SERVICE BULLETIN

Bulletin Number FR028

To: All Owners of Ranger (aka - Kamikaze, Typhoon, Hi-Flyer) Amusement Rides (Pre 1992 Models)

Re: Seat Dividers for Intermediate Seats

SAFETY DIVIDER BAR

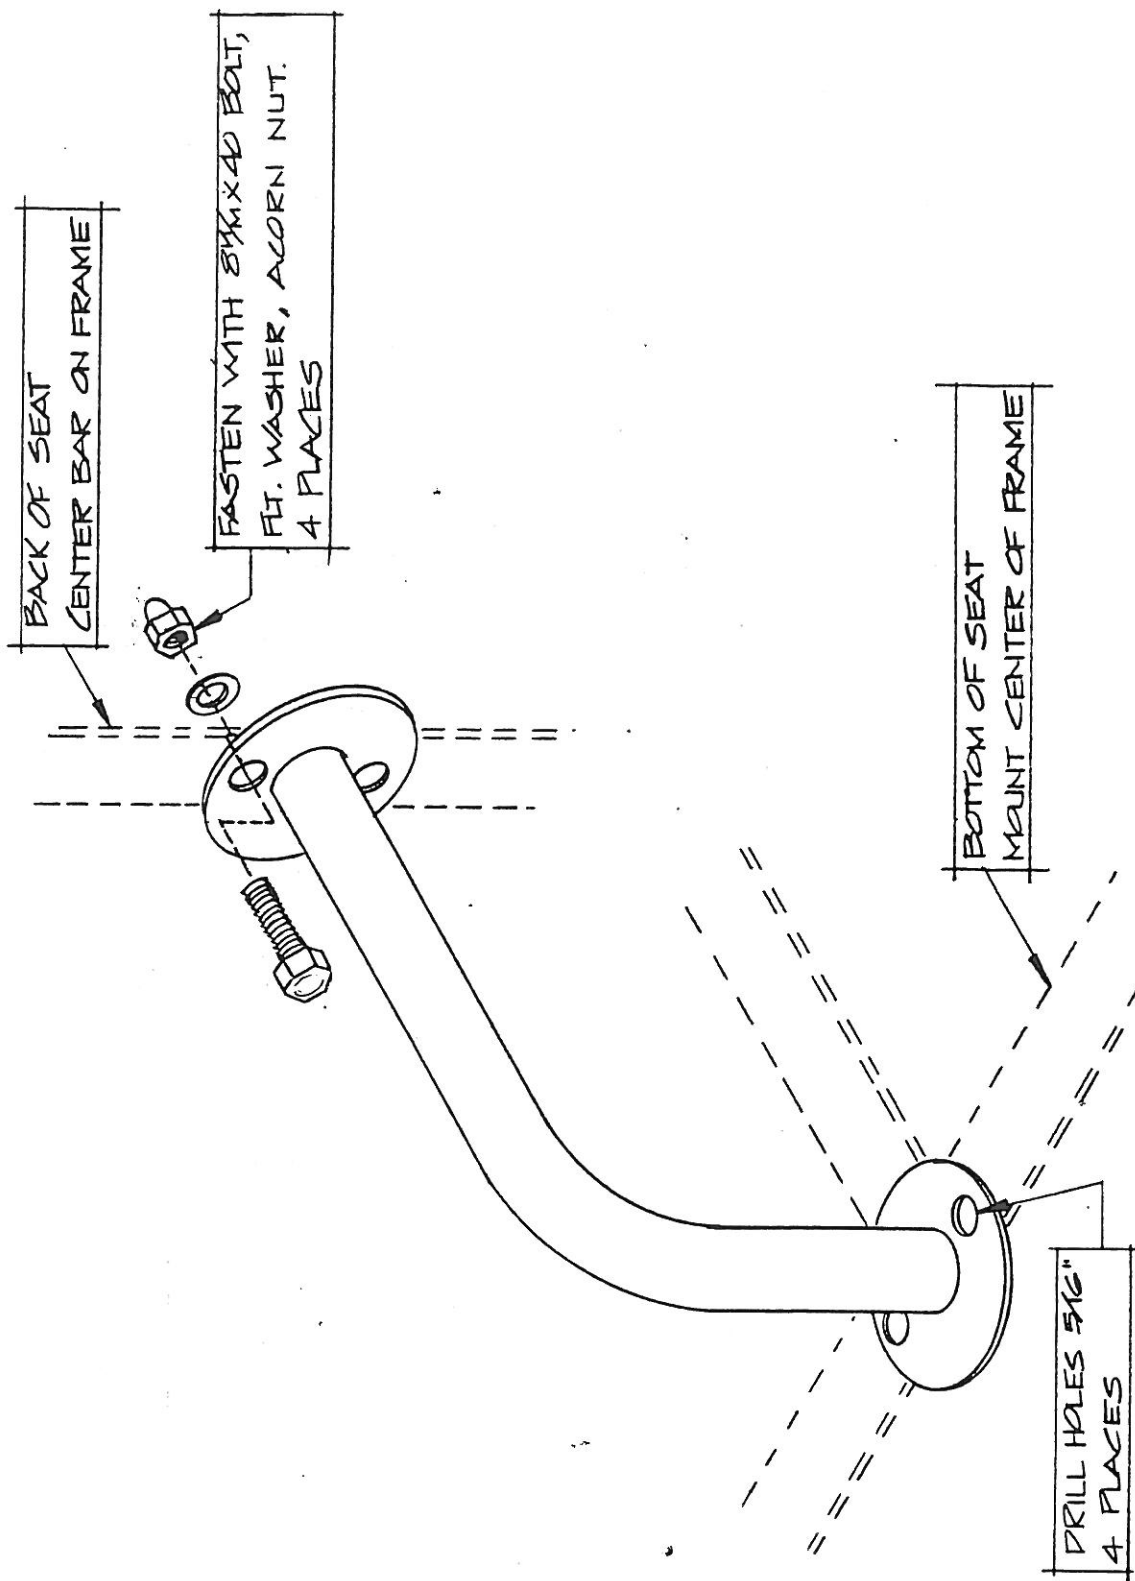
FarFabbri, s.r.l. is mandating that the following adjustment be made on each Ranger Amusement ride as soon as possible. When a passenger is in a seat by himself and the lap bar adjacent to him is in the upright position, it is possible for the passenger to slip from under the shoulder safety bar. This is prevented by the installation of a bar in the middle of every seat (refer to attached drawing). All the seat dividers required for the installation are available free of charge from Exsaco Corporation, P.O. Drawer 328, Alvarado, TX 76009 by ordering three (3) sets of part number 6200450. These materials may be ordered by calling 1-800-545-0667. Once the order has been placed, please send confirmation of installment to Exsaco Corporation.
